GEOLOGICAL SURVEY
RESTON, VA. 22092

Transmitted herewith, in response to the request of your staff, is our review of the geologic and seismologic data relevant to the General Electric Test Reactor at Vallecitos, California.

General Electric Test Reactor
Vallecitos Nuclear Center
Vallecitos, California

Fig. 1.--Tectonic framework of Livermore Valley. Principal active faults are shown. The maximum compressive stress axis is represented by the dark bold arrows.

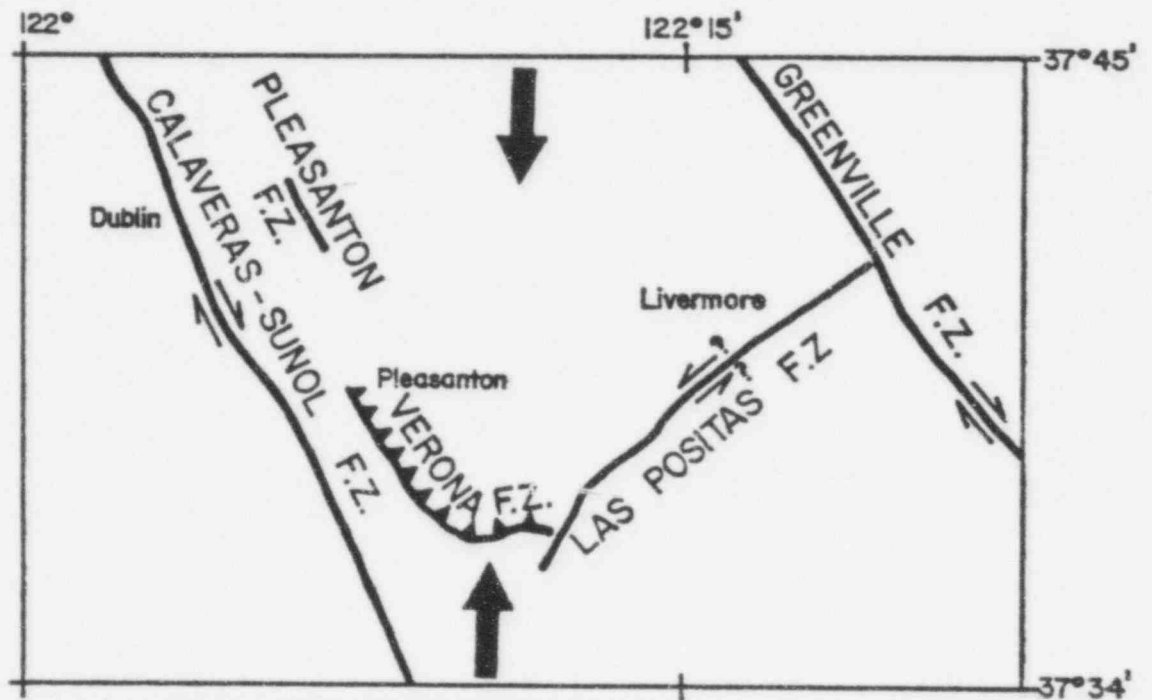
Survey mapping (Fig. 1 is a generalized sketch of Survey mapping) shows the Livermore Valley to be an anomalous east-west-trending valley bounded on the east, south, and west by late Quaternary-age faults. An unusual northeast-trending fault, the Las Positas fault, extends from the southeast corner of Livermore Valley southwest to La Costa Valley, just east of the GETR. The Las Positas fault is evidenced by offset stream terraces, a groundwater barrier, and geologic field relationships. The Las Positas fault is exposed in outcrop along Arroyo Seco south of Lawrence Livermore Laboratory, and has been trenched at the Sandia Laboratories (examined by USGS and CMG geologic personnel). It is interesting to note that in the one area where ESA has conducted

The tectonics of Livermore Valley are controlled by a right-lateral stress couple in the California Coast Ranges caused by the northwestward movement of the Pacific plate past North America. The maximum stress axis of this right-lateral couple in the Livermore Valley area lies at an angle of about 30° to the strike of both the Calaveras-Sunol and Greenville faults (the maximum stress axis of a stress ellipsoid bisects the 60° angle between intersecting strike-slip failure planes of the stress ellipsoid). This right-lateral stress couple causes right-slip movement along the Calaveras-Sunol fault, and could produce left-lateral strike-slip movement along the Las Positas fault, which lies at a 60° angle to the Calaveras-Sunol fault. Although there is no geologically well-documented strike-slip component of movement along the Las Positas fault, the groundwater barrier along the fault near Lawrence Livermore Laboratory (3), possible horizontal slickensides seen in the fault zone in trenches at the Sandia Laboratories, and change in direction in face of scarps along the fault are consistent with left-lateral strike-slip movement.

Thrust movement along a west- to west-northwest-trending Verona fault would be expected because the fault lies nearly perpendicular to

the maximum stress axis. The Verona fault apparently joins the Las Positas fault east of the GTR (the southeastward prolongation of the Verona fault is exposed in both trench A and in the La Costa Water Tunnel), and left-lateral strike-slip movement along the Las Positas fault would cause westward thrusting of Livermore Gravels along the Verona fault.

North-south extension of Livermore Valley, which was originally proposed by the licensee's consultant (6) to explain the tectonics of the valley and to negate the possibility of thrust faulting along the Verona fault, mechanically cannot exist. The valley is compressed in a north-south direction by the maximum compressive stress which causes right-lateral strike-slip movement along the northwest-trending faults in the California Coast Ranges.
